Review 1

Preliminary and Final Major Site Plan
111 Avenue F Partners Urban Renewal LLC

89-92 East 22nd Street; 107-111 Avenue F
Block 456, Lots 7, 8.01, 8.02, 8.03, 9 and 10
Avenue F Redevelopment Area Plan
Application No. P-24-021

August 8, 2024

Table 1: Area & Yard Requirements – §5.7

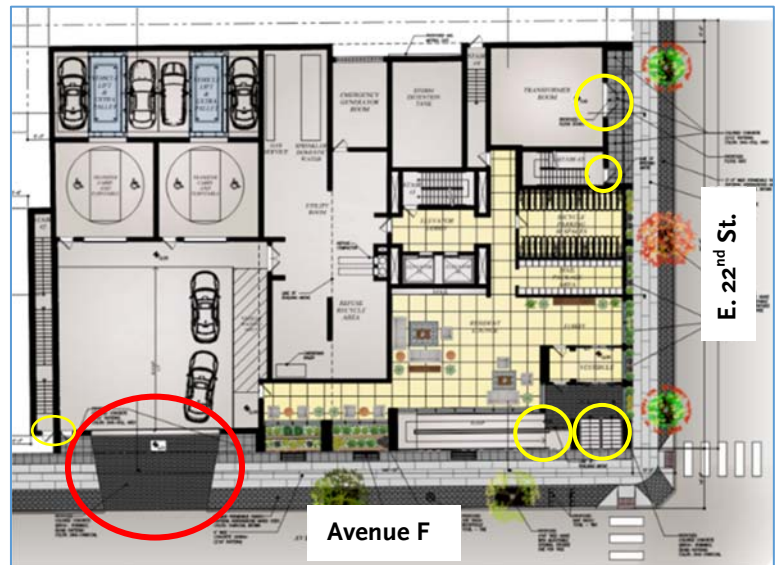
- 3.2. **Maximum Height – 1st Story.** Pursuant to §5.7.A.2, *the first story may be up to 30 feet as measured from the first floor elevation to the highest elevation of the ceiling to accommodate mechanical parking. The first story with parking may consist of multiple levels of fully automated parking, semi-automated parking, ramped surface parking, or any combination thereof. These multiple parking levels shall be construed as a single building story as defined herein, provided such parking is contained within the first floor. Other building support spaces may also be provided on multiple levels on the first floor, including, but not limited to utility rooms, mechanical and electrical rooms, building entrance lobbies, and building amenity spaces.* The proposed ground level contains three levels of mechanical parking. In addition to parking, the three levels also contain utility rooms, refuse areas, lobbies, bicycle parking, and shared amenity space, all of which is permitted within the three-level ground floor. The proposed height of the ground floor is 33.96 feet, above the maximum permitted 30 feet in height. **A variance is required. This office notes that this necessitates a “-c” variance, rather than a “-d(6)” variance, which is specific to overall building height, not the height of portions of a building.**

- 3.3. **Minimum Setback of Floors 5 and Above – Avenue F.** Pursuant to §5.7.D.1, the minimum setback to Avenue F for floors five and above is 10 feet or the height of the fifth floor, whichever is greater. The height of the fifth floor is 10 feet and one inch, while the setback is 10 feet. **A variance is required, though *de minimis* in nature.**

Rooftop Detail Indicating in Yellow Proposed Planters.

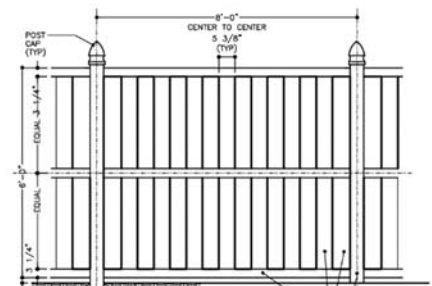
5.6. **Rooftop Landscaping.** As indicated in the following image depicted in yellow, three potted trees and a number of shrubs are proposed on the roof. The plants are not identified on the plan. Pursuant to §6.7.D, rooftop plantings are required to be hardy, native (or native-adapted) species, which are able to thrive in an urban environment. Rooftop planters are required to have adequate drainage and may include storage reservoir systems, irrigation and root barriers as a means of aiding plant growth and maintenance. **These details should be provided, and the planting list should also be provided; meeting the specifications of the Redevelopment Plan. Should the Board desire, a condition of approval could be that our office provides assistance to the applicant with choosing plants for the rooftops.**

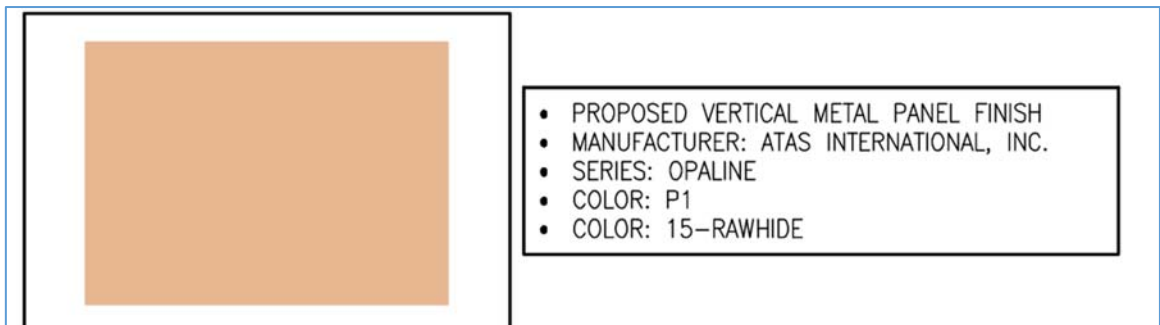
9.7.7. Color Palette. Buildings shall be designed using a color palette that complements the architectural context of the surrounding area. Color palettes should be traditional and durable colors like beige, terra cotta, brick red, dark green, black and various grays are natural or muted and work well with the brick and stone facades of existing historic buildings in Bayonne. Overly bright, garish colors are to be avoided. Generally, one or two colors should be selected. The base color is the predominant color applied to the walls and major surfaces. Accent color is used for trim, hardware, doors, etc. The use of too many colors should be avoided. **The use of the “Rawhide” color, which appears as a peach/tan mix appears out of place. It is recommended that this color be replaced with something with less red in the color mix (though this office is open to other suggestions which match the**

requirement), as the peach color does not correspond to the required color palette or “loft industrial” style. The color sample is included herein for reference. If the color appears differently when not viewed on a screen, the applicant should provide a hard version of the color swatch at the hearing for further determination of the color’s conformance with the requirements. The other colors chosen are appropriate.
